# PERMIT

## TAX ID #05-357810 ON-SITE SEWAGE DISPOSAL SYSTEM HOWARD COUNTY HEALTH DEPARTMENT BUREAU OF ENVIRONMENTAL HEALTH

SUBDIVISION: Linthicum Oaks-Tenant House LOT NUMBER: Tenant House

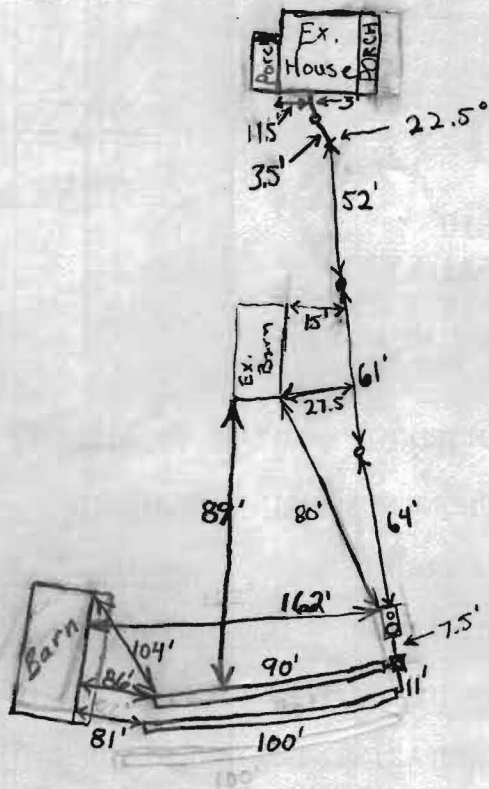
PRE-CONSTRUCTION 1x100' and 1x90' trenches to be installed on contour ok to go slightly outside easement. Inlet & Bottom 1' deeper than designed

Need to Seal Well, Tank Pumped and Filled In
